ADDENDUM DRAWING ADD 007	JOB NUMBER 2002490
	DATE 11-21-2007
PROJECT FOR: BAKERSFIELD CITY SCHOOL DISTRICT 1300 BAKER ST BAKERSFIELD CA 93301

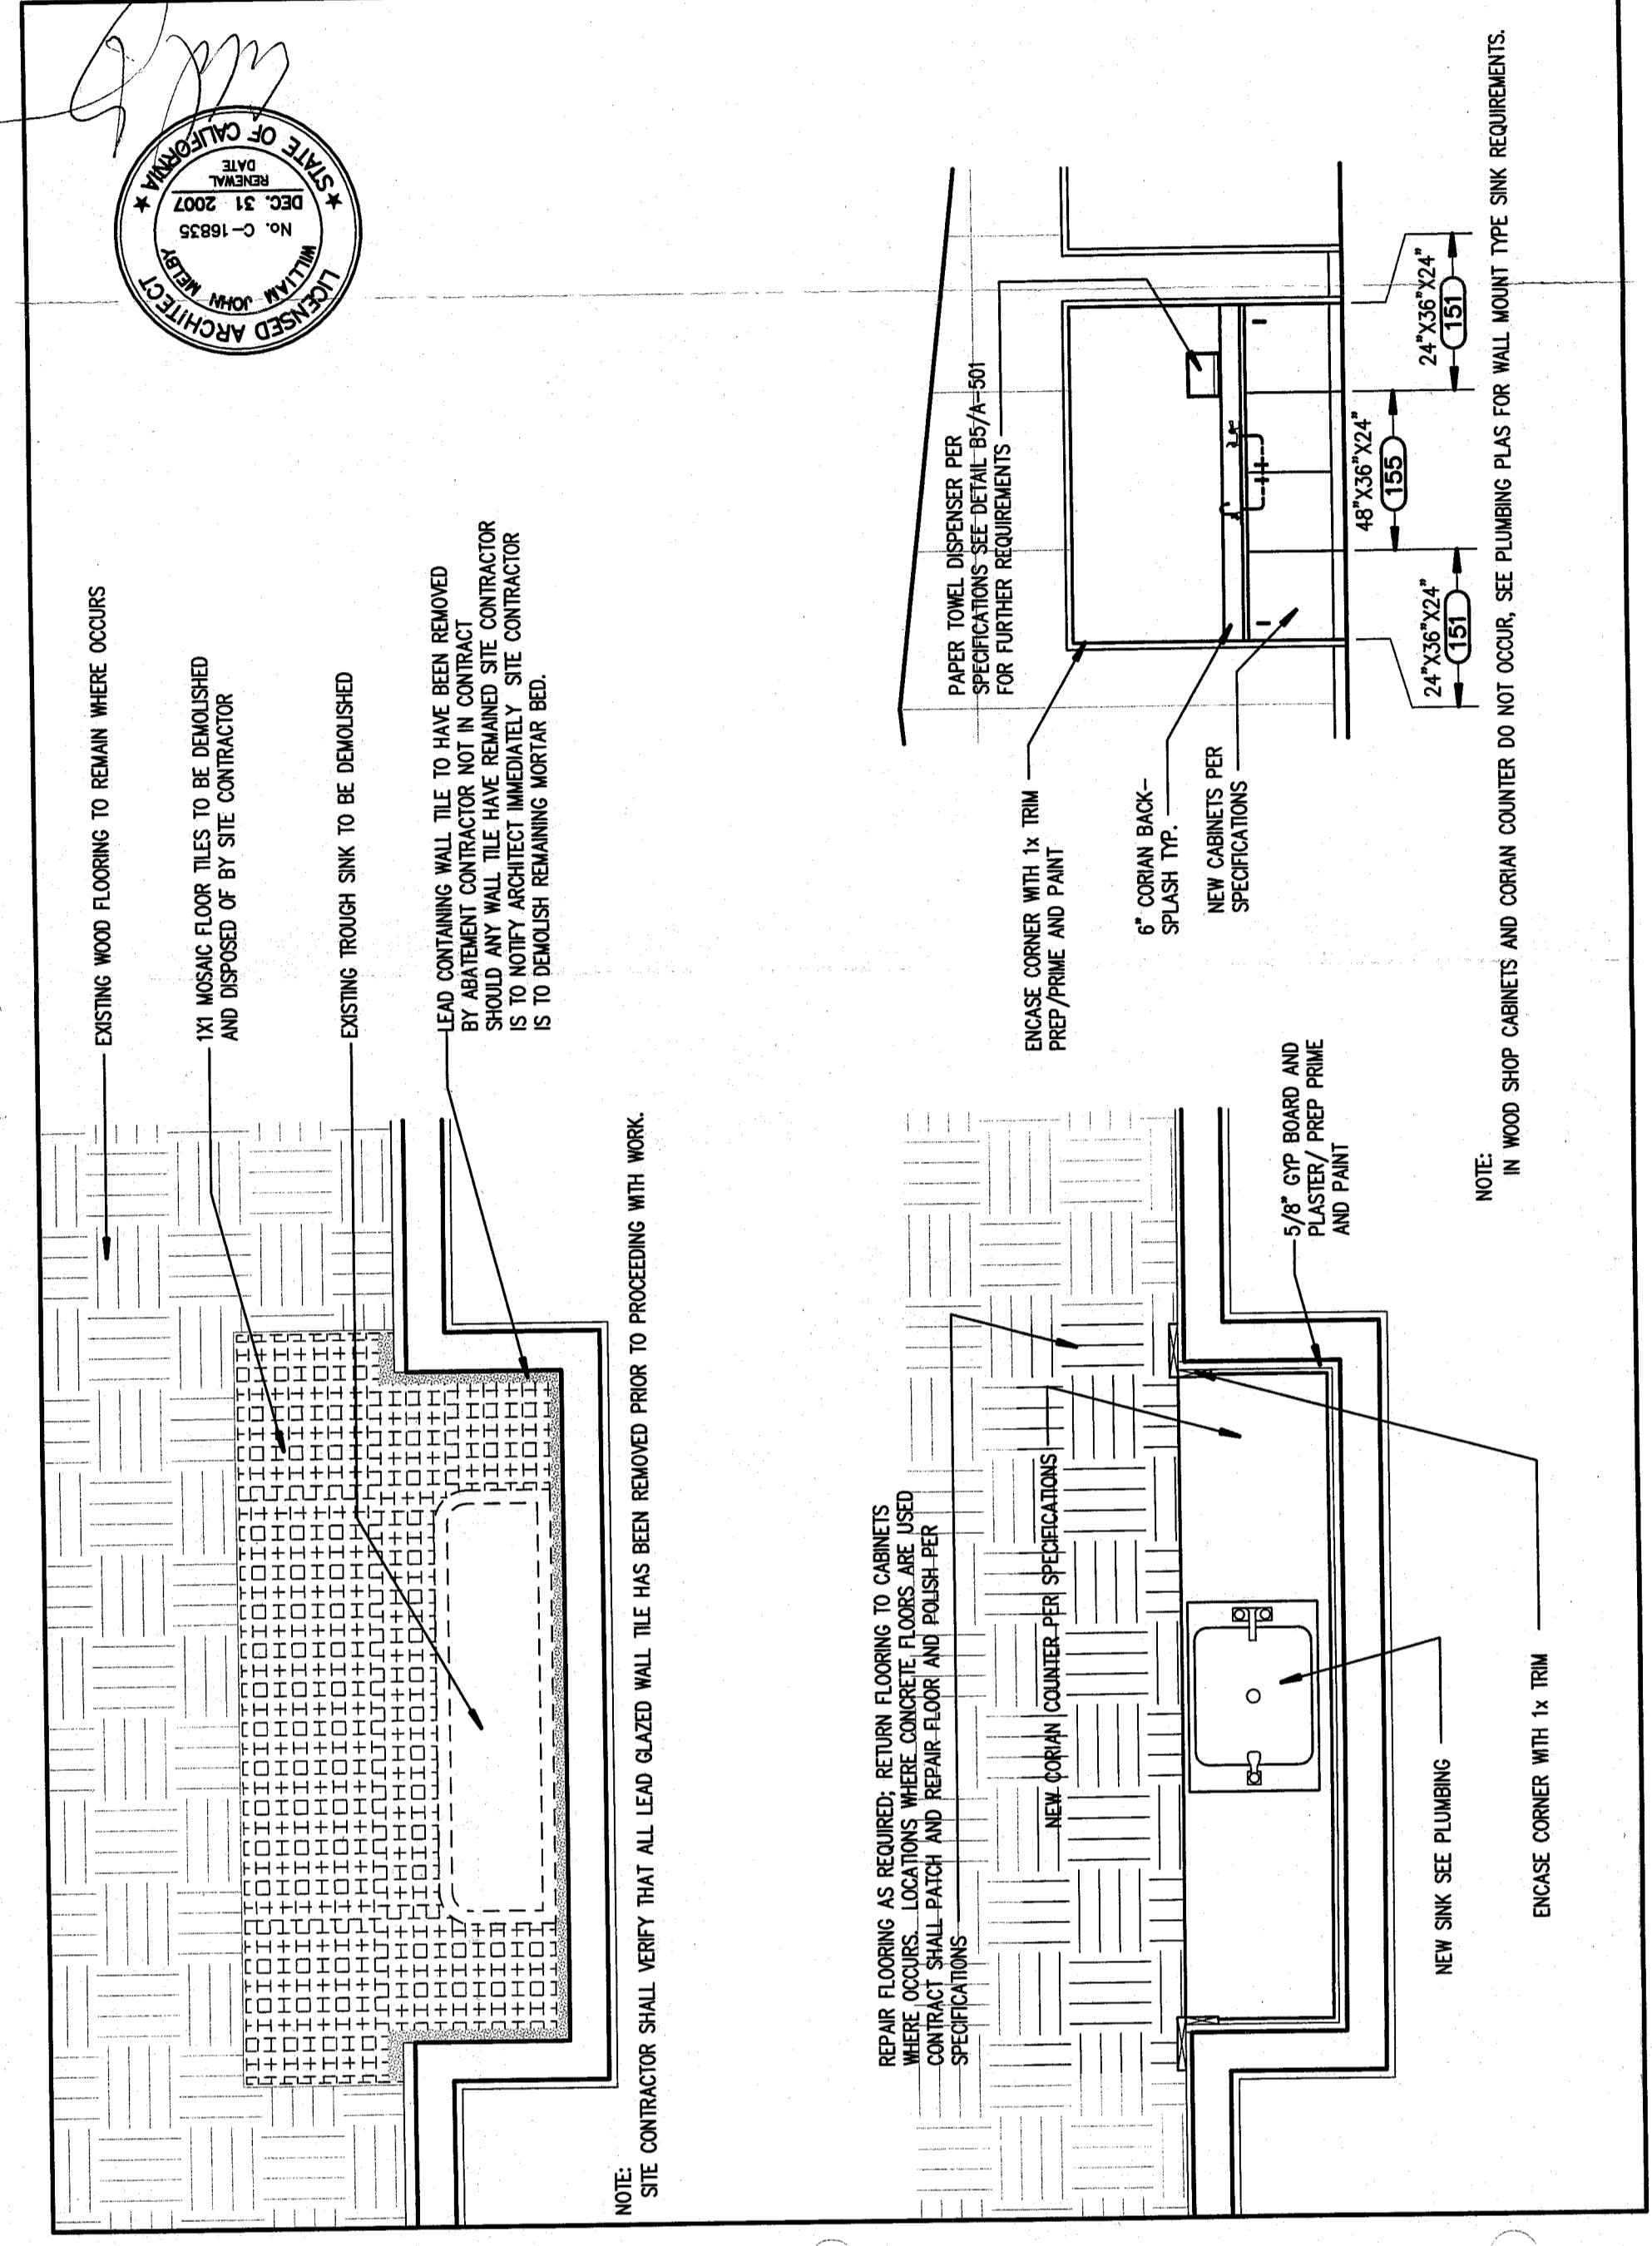
EXISTING WOOD FLOORING TO REMAIN WHERE OCCURS
 1X1 MOSAIC FLOOR TILES TO BE DEMOLISHED
 AND DISPOSED OF BY SITE CONTRACTOR
 EXISTING TROUGH SINK TO BE DEMOLISHED
 LEAD CONTAINING WALL TILE TO HAVE BEEN REMOVED
 AND DISPOSED OF BY SITE CONTRACTOR
 SHOULD ANY WALL TILE HAVE REMAINED SITE CONTRACTOR
 IS TO NOTIFY ARCHITECT IMMEDIATELY. SITE CONTRACTOR
 IS TO DEMOLISH REMAINING MORTAR BED.

NOTE: SITE CONTRACTOR SHALL VERIFY THAT ALL LEAD GAZED WALL TILE HAS BEEN REMOVED PRIOR TO PROCEEDING WITH WORK.

REPAIR FLOORING AS REQUIRED; RETURN FLOORING TO CABINETS
 WHERE OCCURS. LOCATIONS WHERE CHECKS USED
 TO MATCH FLOOR FINISH, COLOR AND PATTERN PER
 SPECIFICATIONS

NEW CORIAN COUNTER PER SPECIFICATIONS
 5/8\" OFF BOARD AND
 FLASHBY/ PREP PRIME
 AND PAINT
 NEW SINK SEE PLUMBING
 ENCASE CORNER WITH 1/4 TRIM

ENCASE CORNER WITH 1/4 TRIM
 PREP/PRIME AND PAINT
 6\" CORIAN BACK-
 SPLASH TOP
 NEW CABINETS PER
 SPECIFICATIONS
 PAPER TOWEL DISPENSER PER
 SPECIFICATIONS 48 1/2\"-50\"
 FOR OTHER REQUIREMENTS
 48 1/2\" 24\" 24\" 24\"
 48 1/2\" 24\" 24\" 24\"
 48 1/2\" 24\" 24\" 24\"

NOTE: IN WOOD SHOP CABINETS AND CORIAN COUNTERS DO NOT OCCUR, SEE PLUMBING PLAN FOR WALL MOUNT TYPE SINK REQUIREMENTS.
